Conclusion

The proposed changes are considered to be non-material in nature. The amendments seek to refine the approved scheme improve efficient use of material and ensure a deliverable design that does not compromise on quality. The aspiration to deliver a vibrant, yet functional industrial offering remains true.

Lift Tower Cladding

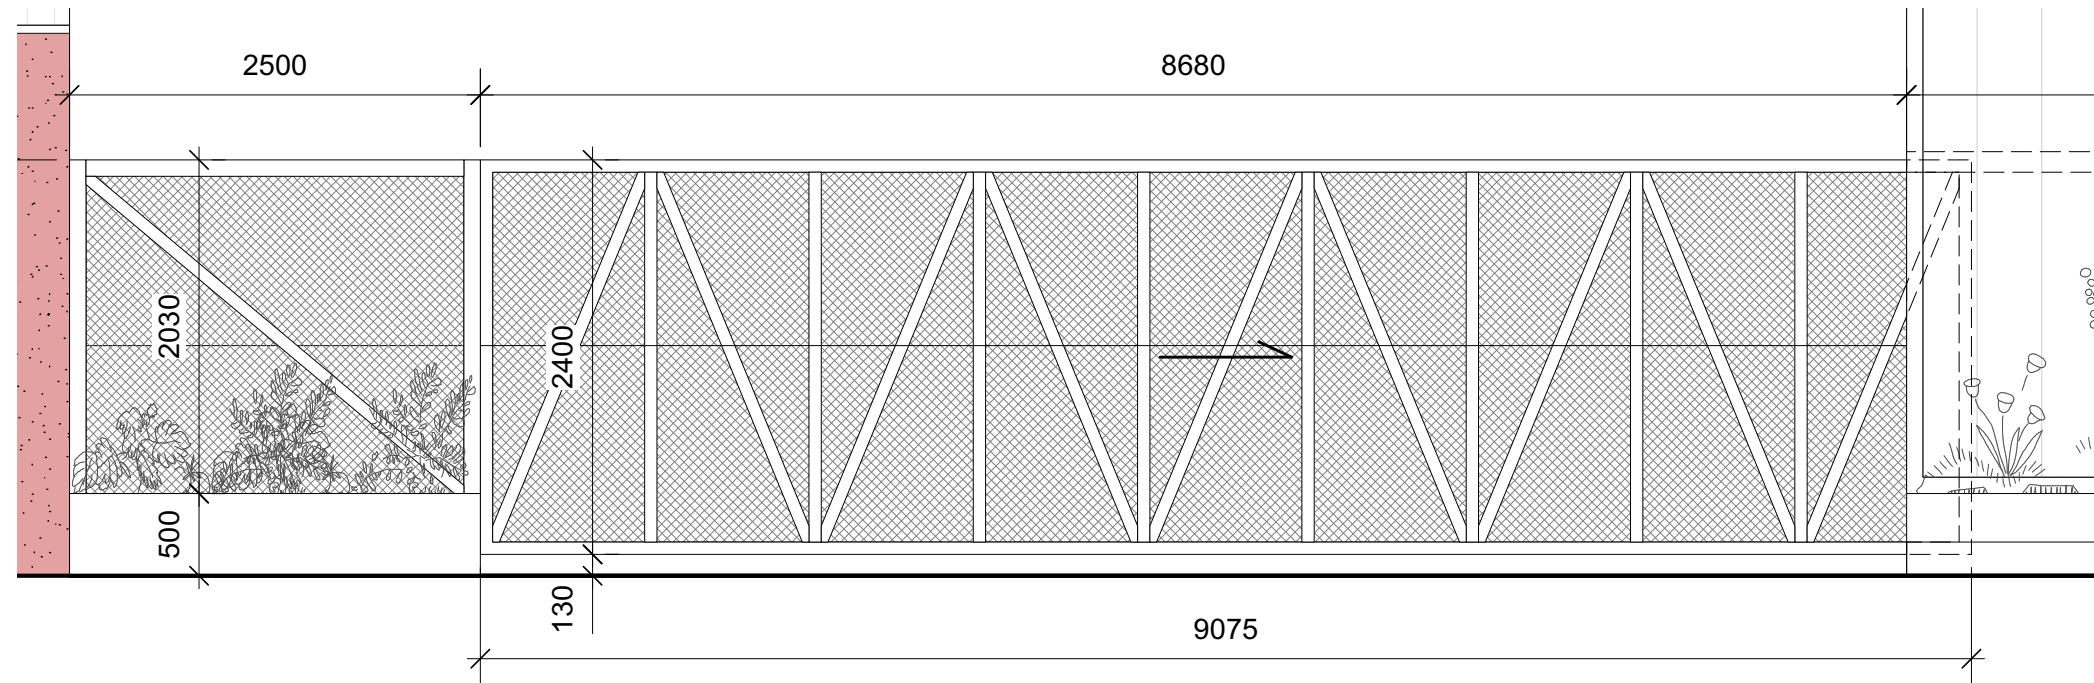
– All lift tower cladding changed from painted metal grating to multi-layered engineered polycarbonate. This is to ensure a water tight enclosure to the lift.

Gates to Vale Road

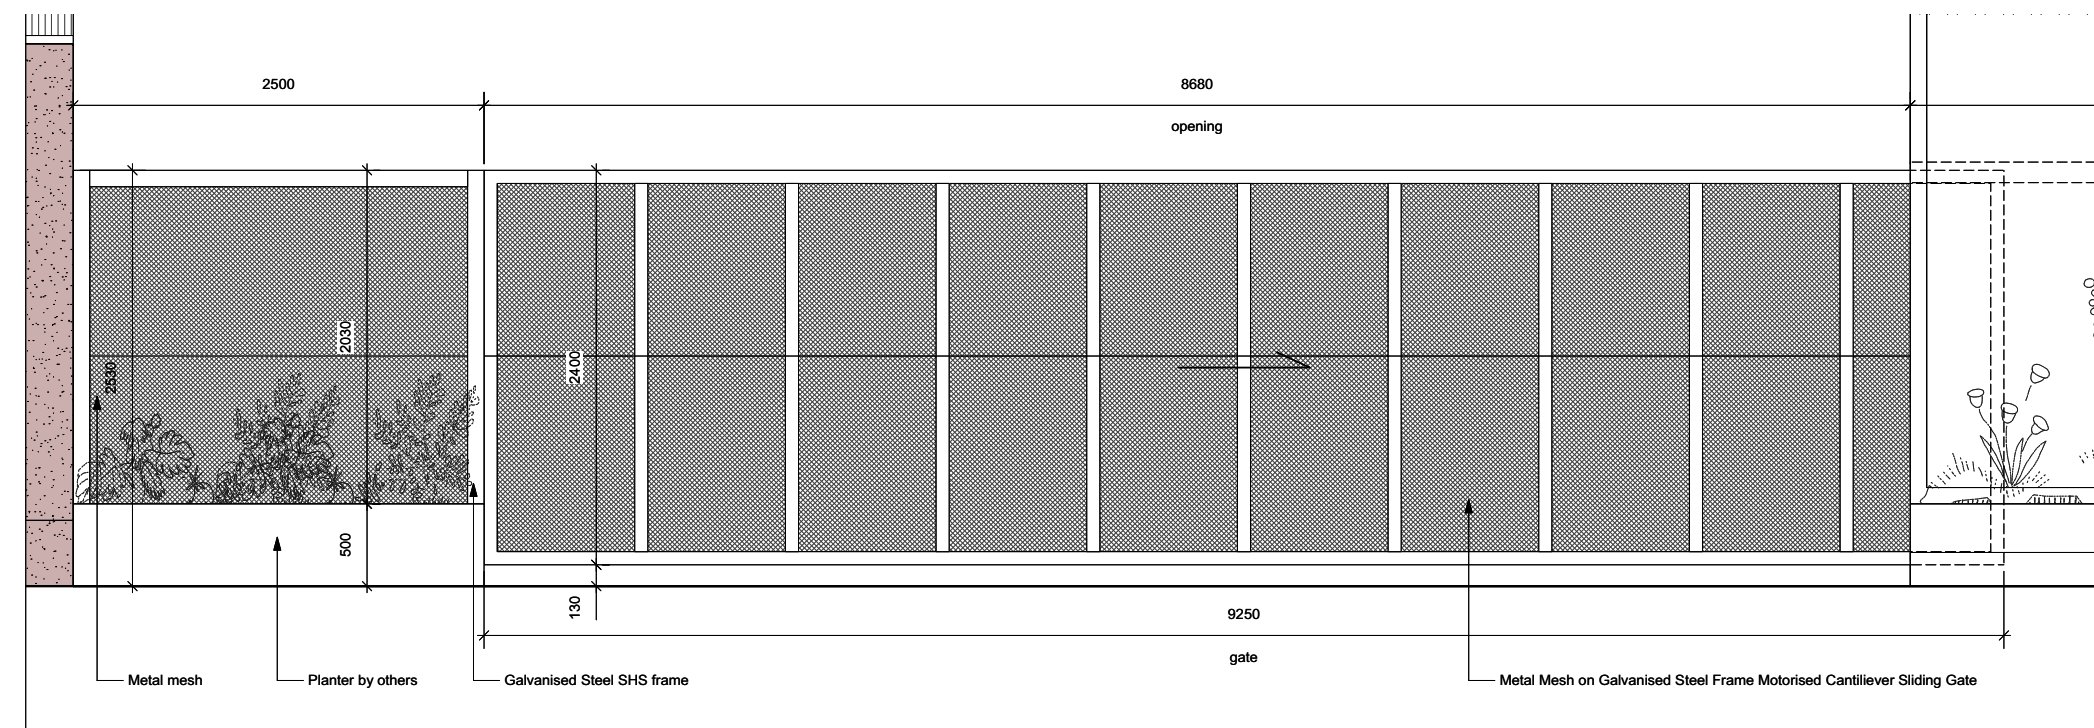
– Metalwork to gate simplified. Bracing removed to minimise use of material and refine detail further.

External Walkways and Stairs

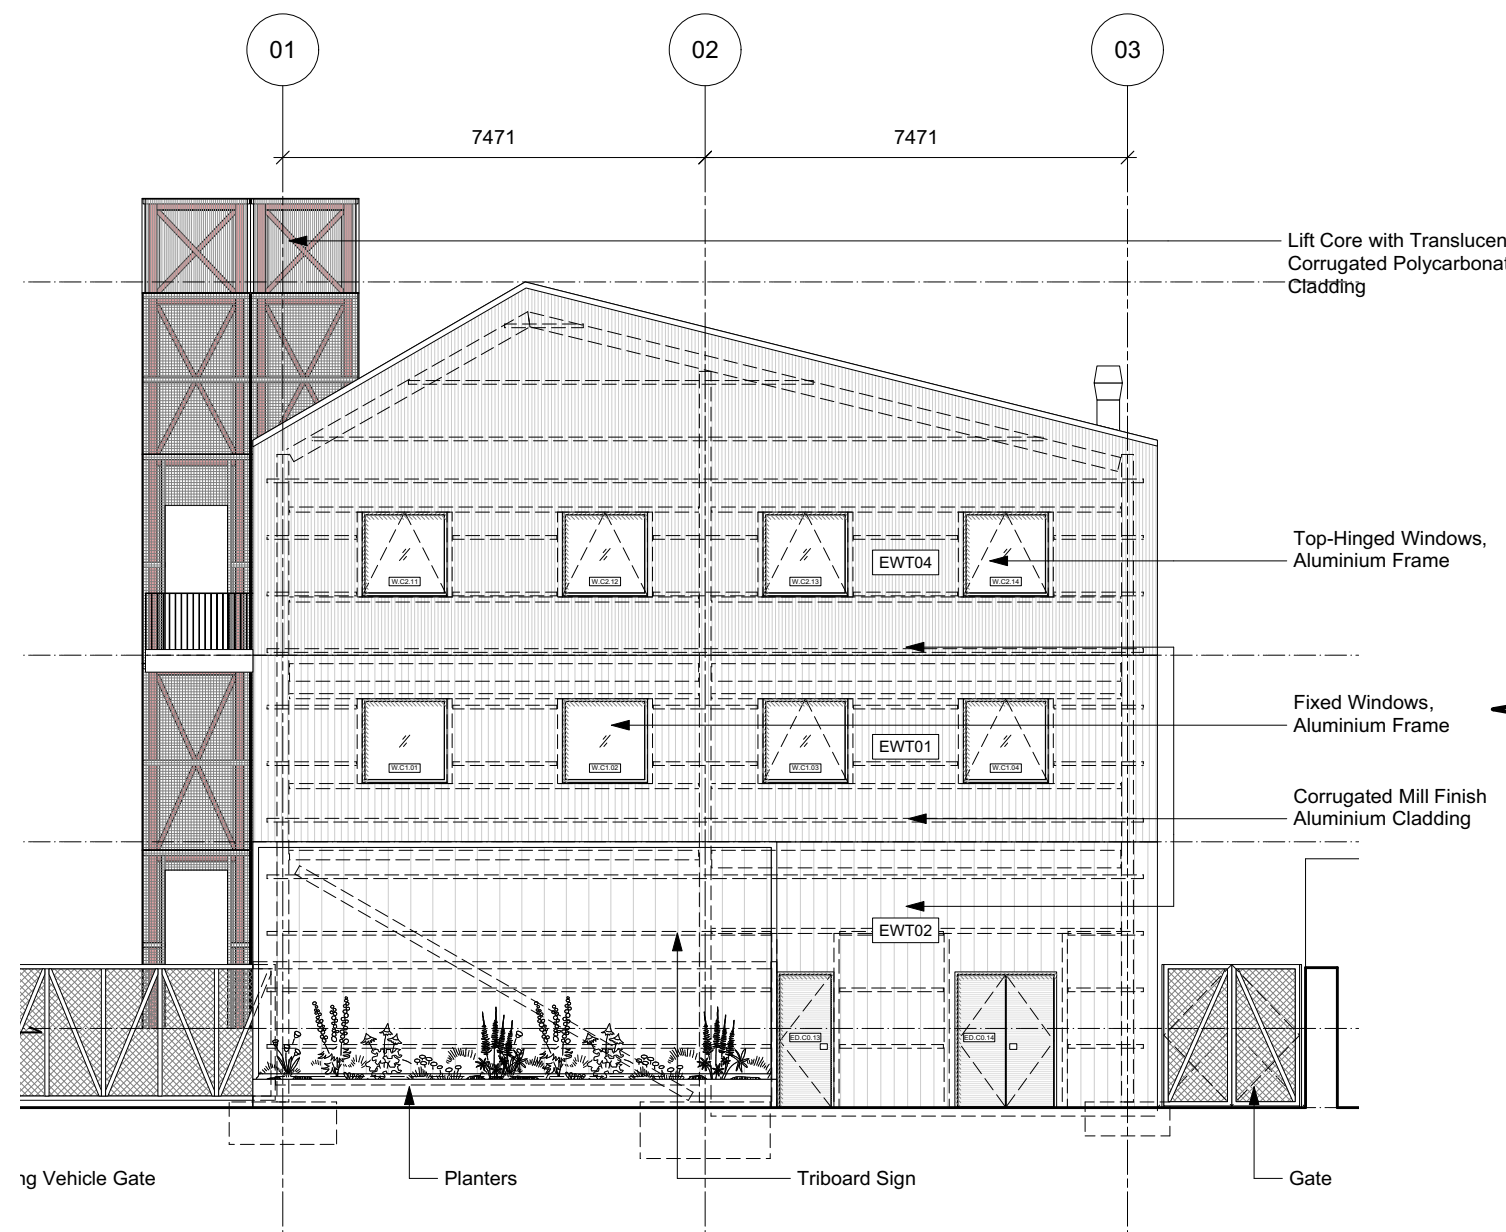
– Powder coated metal grating altered to GRP grating with painted metal balustrades. (Colour indicative)

Block C Signage and Plant Room

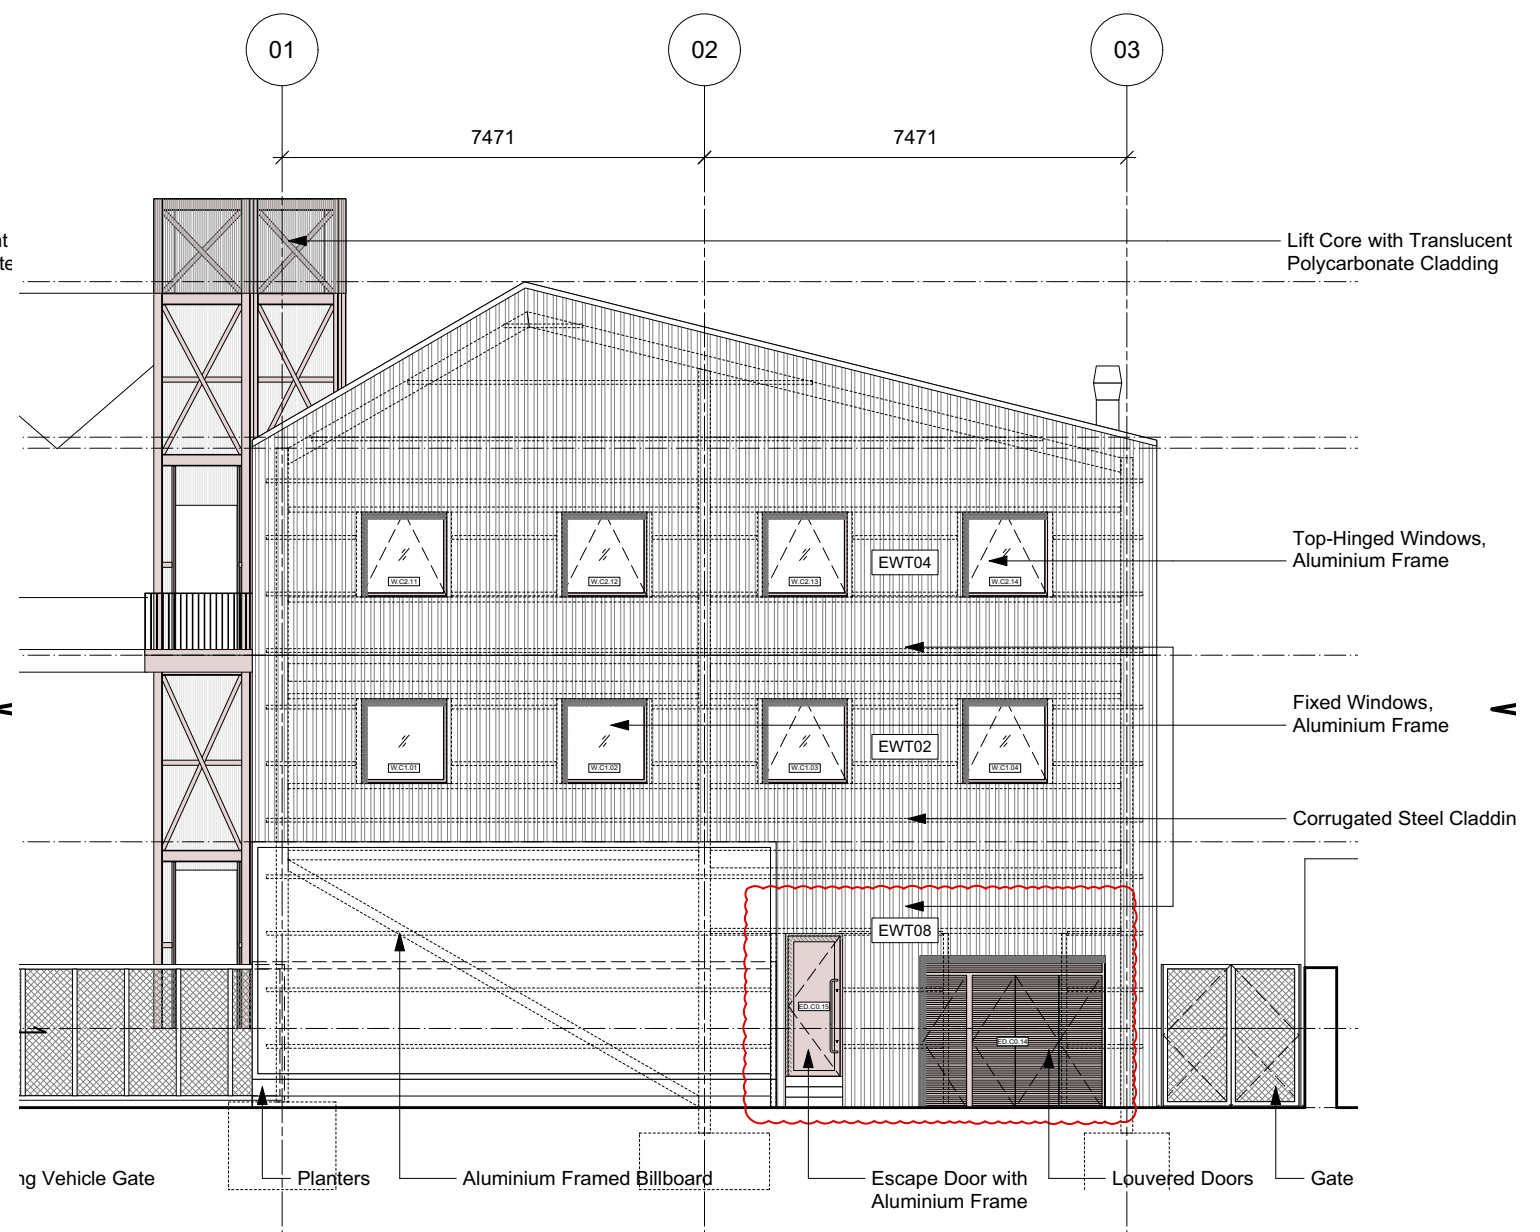
- Rotating triboard sign changed to fixed billboard with graphics TBC
- Change in plant room louvered doors to align with UKPN requirements
- Change to escape door level egress to accomadate UKPN changes
